To: City Council via Planning Commission
From: Jon Lundell, P.E., City Engineer
Date: February 17, 2022
Re: **Santaquin City Standards and specifications update**

ORDINANCE NO. 03-01-2022

Changes made to the Santaquin City Standard Specification and Drawings

STANDARD DRAWING NUMBER:	CG5
CAD DWGd.dwg_6-12.dgn	
PLOT SCALE:	1:000
DRAWN BY:	BTW
DESIGN BY:	NEB
CHECKED BY:	MLC
ADOPTED DATE:	20 JUN 12

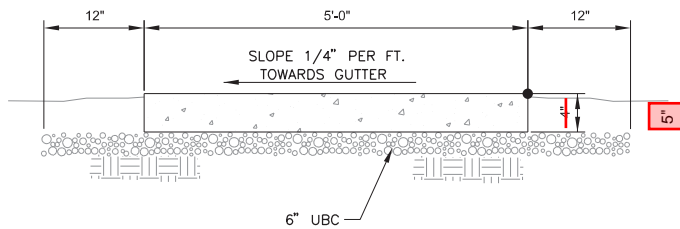
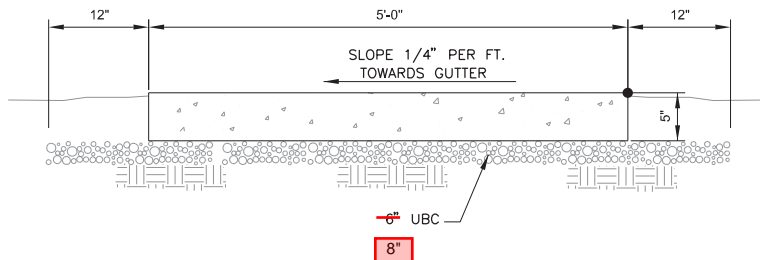
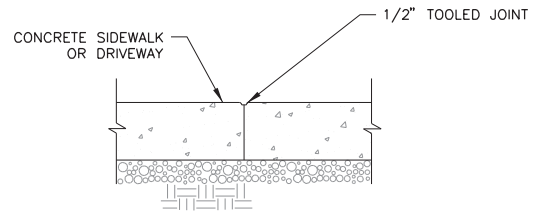
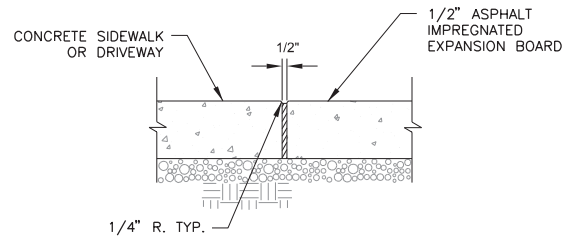
- Sheet CG5 – Changes the Sidewalk Cross Section to 5" of concrete for residential sidewalk and changes to 8" of road base for commercial sidewalks.

PI2

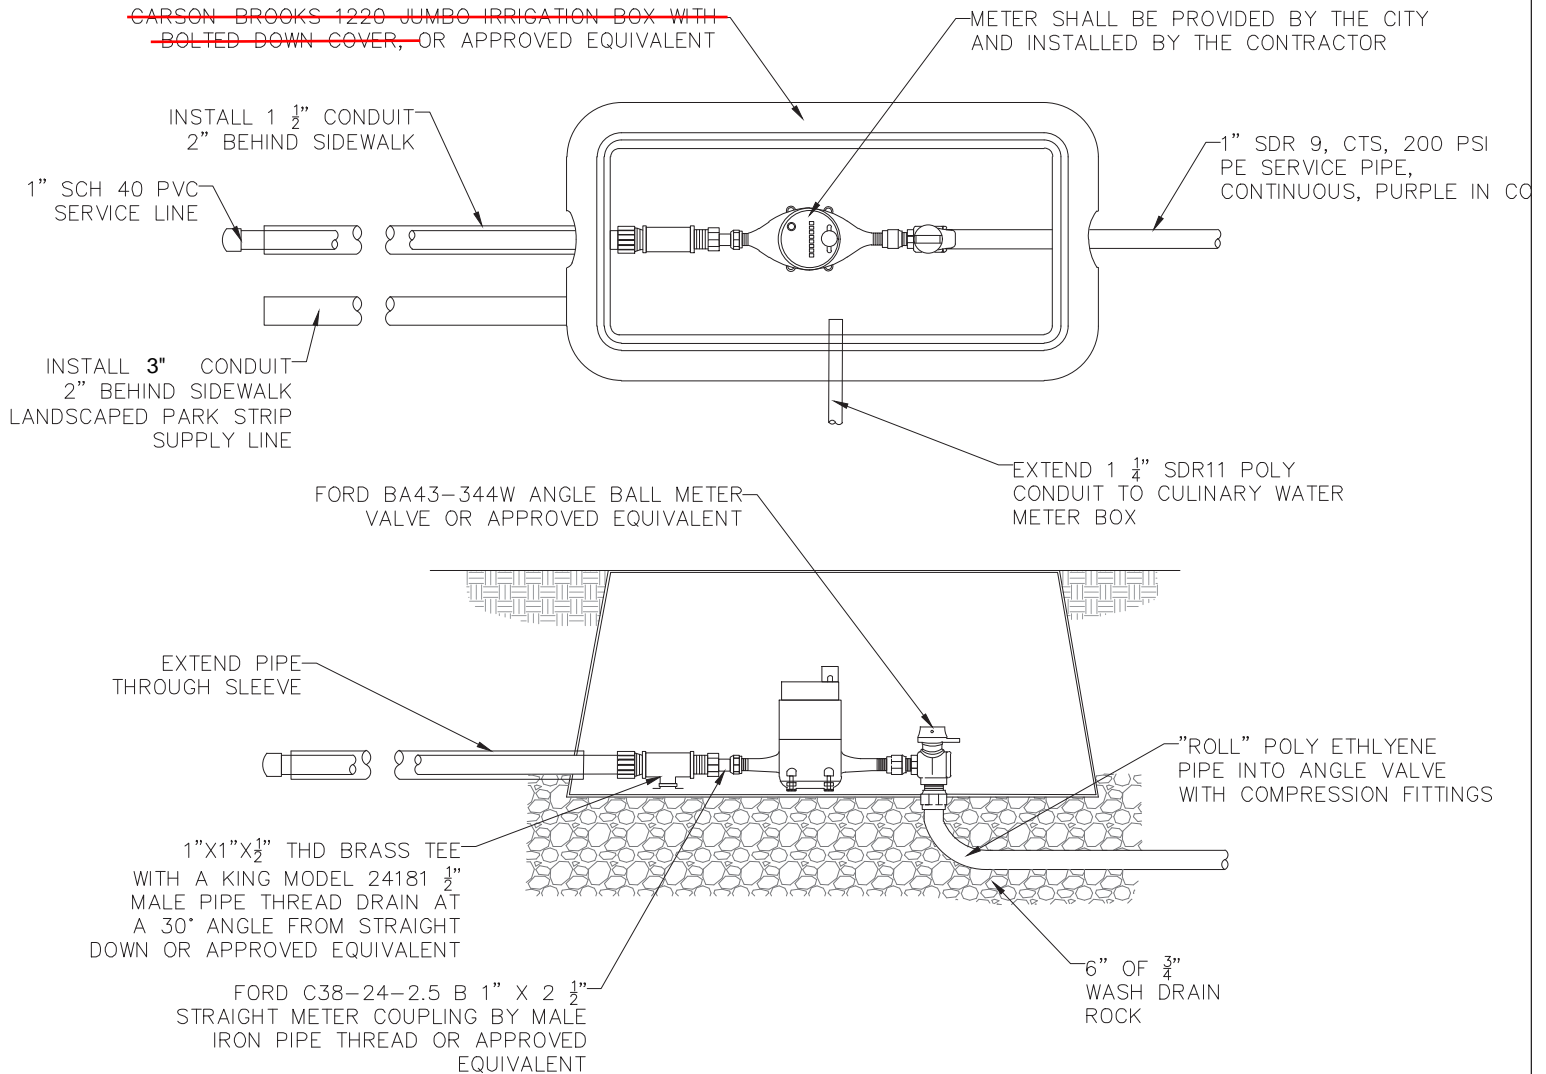
- The proposed change to section 3.05 Subsection F addresses an issue of vehicles driving over the residential pressurized irrigation boxes and damaging the meter boxes. This update also adds text to match the standard drawing for pressure irrigation service connections shown on standard drawing PI 2??

~~CARSON BROOKS 1220 JUMBO IRRIGATION BOX WITH
BOLTED DOWN COVER, OR APPROVED EQUIVALENT~~

DFW PLASTICS 1324C4-12-4T 63D

ST2

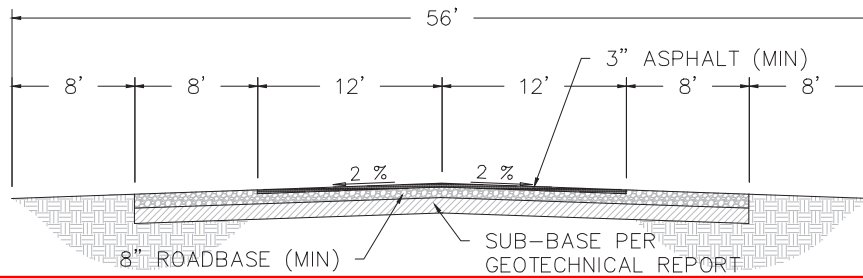
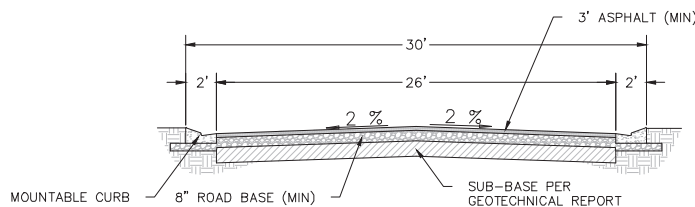
- Adjusted Cul-de-sac diameter to be 96 feet (per IFC code appendix D103.1)
- Sheet ST2 – Added note:
 - 26' private street cross section will no longer be used within developments that submit a complete development application after the September 2, 2017.

- 55" Rural local road cross section will no longer be used within developments that submit a development application after the date that these specifications are approved.

55' RURAL LOCAL ROAD STREET CROSS SECTION WILL NO LONGER BE USED WITHIN DEVELOPMENTS THAT SUBMIT A COMPLETE DEVELOPMENT APPLICATION AFTER THE DATE THAT THESE SPECIFICATIONS ARE APPROVED.

26' PRIVATE STREET CROSS SECTION WILL NO LONGER BE USED WITHIN DEVELOPMENTS THAT SUBMIT A COMPLETE DEVELOPMENT APPLICATION AFTER SEPTEMBER 2, 2017

UT2

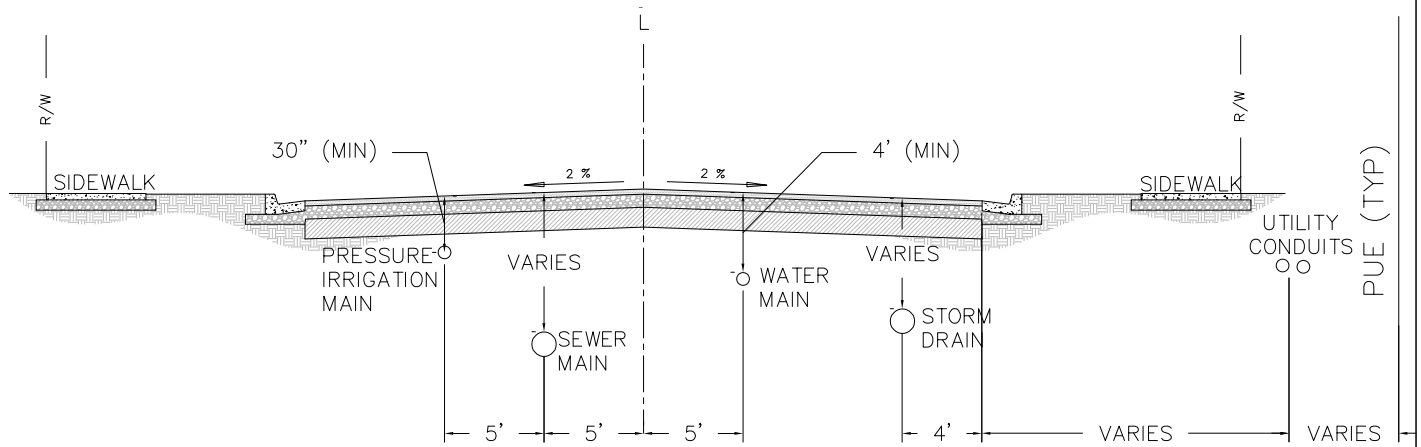
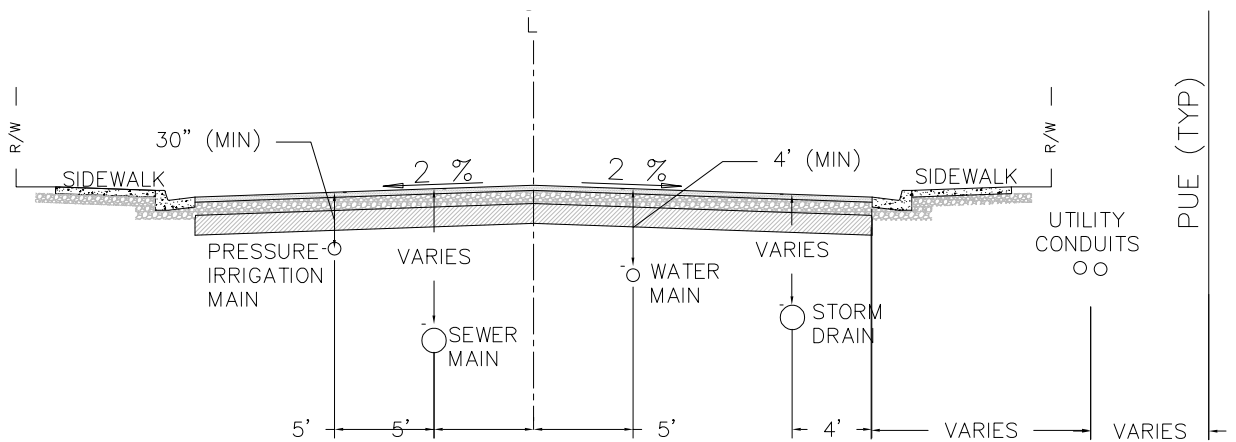
- Sheet UT2 - Include location of 2-2" utility conduits
- Sheet ST3 –
 - Added note: 55' street cross section will no longer be used within developments that submit a development application after the date that these specifications are approved.

1. IRRIGATION MAINS SHALL BE LOCATED 10 FEET SOUTH & WEST OF CENTER OF THE STREET.
2. WATER MAINS SHALL BE LOCATED 5 FEET NORTH & EAST OF CENTER OF THE STREET.
3. SEWER MAINS SHALL BE LOCATED 5 FEET SOUTH & WEST OF THE CENTER OF THE STREET.
4. STORM DRAIN SHALL BE LOCATED 4 FEET FROM THE LIP OF GUTTER ON NORTH & EAST SIDE OF THE STREET.
5. STORM DRAIN SHALL BE LOCATED LOWER THAN THE WATER MAIN.
6. UTILITY CONDUITS: SEE SECTION 17.02

W1

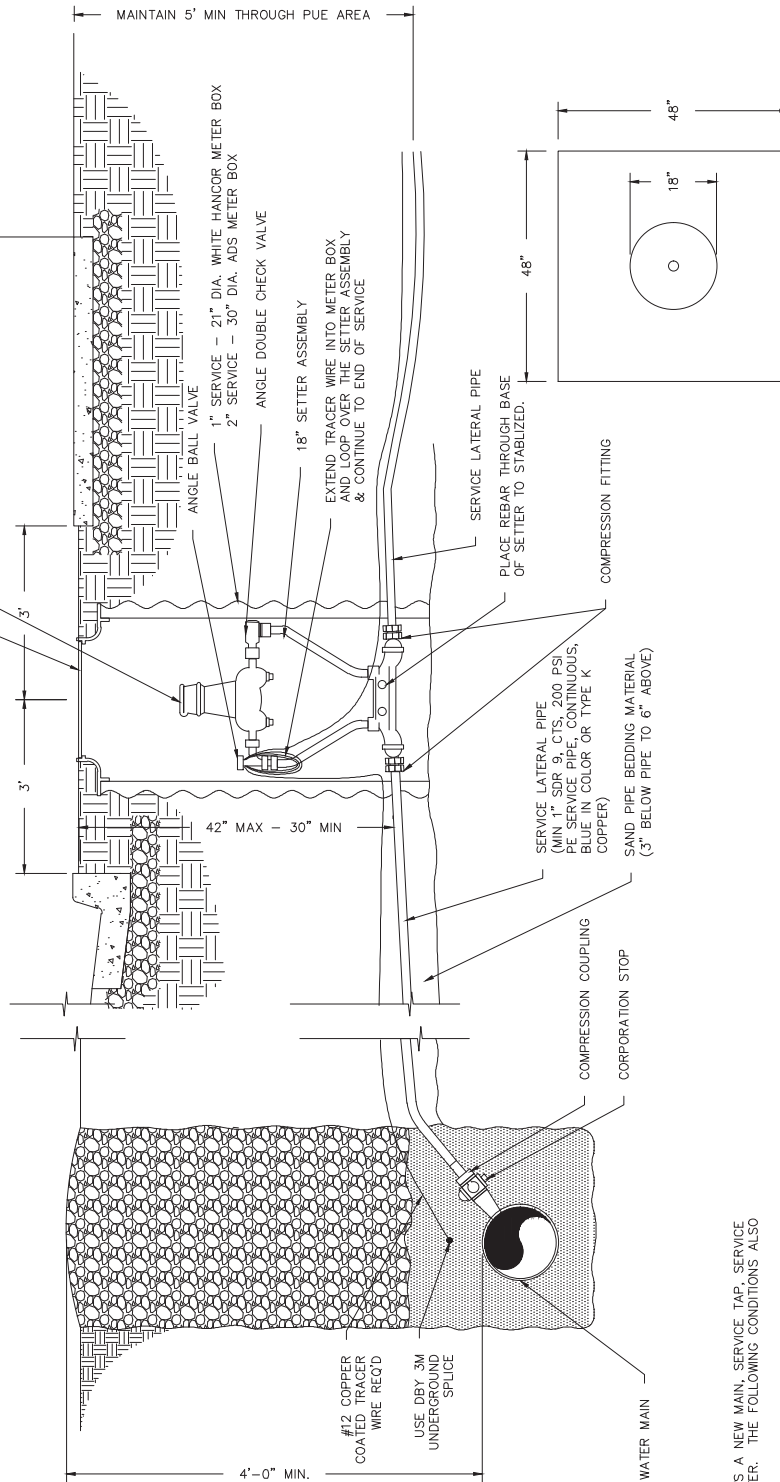
- Sheet W1 – Water meter lid update Part # DFW12AFD-1WT 63D-LID (Consistent with Division 3A text change listed above)

DFW PLASTICS DFW12AFD-1WT 63D-LID

METER BOX TOP RING AND COVER
~~63D-LID-1WT-63D~~
(LOCATE WITHIN 1" OF THE TOP OF SIDEWALK)
